Final Product/Process Change Notification

Document #:FPCN22623X1

Title of Change:	Assembly and test manufacturing for NCP170 SOT563 family transfer to Leshan Phoenix Semiconductor, China.
Proposed First Ship date:	01 Jun 2020 or earlier if approved by customer
Contact Information:	Contact your local ON Semiconductor Sales Office or Jan.Gryzbon@onsemi.com
PCN Samples Contact:	Contact your local ON Semiconductor Sales Office or <PCN.samples@onsemi.com>. Sample requests are to be submitted no later than 30 days from the date of first notification, Initial PCN or Final PCN, for this change. Samples delivery timing will be subject to request date, sample quantity and special customer packing/label requirements.
Additional Reliability Data:	Contact your local ON Semiconductor Sales Office or Tomas.Vajter@onsemi.com
Type of Notification:	This is a Final Product/Process Change Notification (FPCN) sent to customers. FPCNs are issued 90 days prior to implementation of the change. ON Semiconductor will consider this change accepted, unless an inquiry is made in writing within 30 days of delivery of this notice. To do so, contact PCN.Support@onsemi.com

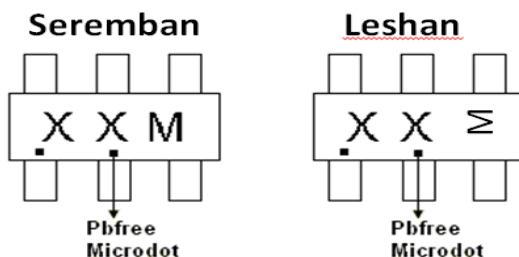
Before Change Description	After Change Description
Mold Compound	EME-G700LS	Hysol GR640HV-L1 M7A
Assembly Site	Seremban	Leshan
Test Site	Seremban	Leshan

From	To
Product marking change	M = Month Code, rotate=0°	M = Month Code, rotate=270°

Product assembled in Leshan, China will include the trace character of 'M' (rotated 270 degrees) in the trace. There are no other changes to the product marking as a result of this notification.

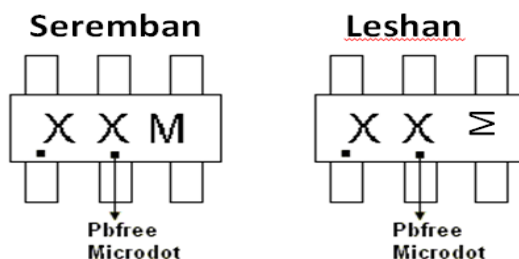
変更前の表記	変更後の表記
モールド・コンパウンド	EME-G700LS	Hysol GR640HV-L1 M7A
組立拠点	Seremban	Leshan
検査拠点	Seremban	Leshan
	変更前	変更後
製品マーキング変更	M = Month Code, rotate=0°	M = Month Code, rotate=270°

楽山 (中国) で組み立てられる製品には、トレース文字「M」(270 度回転) がトレースコードに付与されます。今回の通知の結果として製品マーキングへのその他の変更はありません。
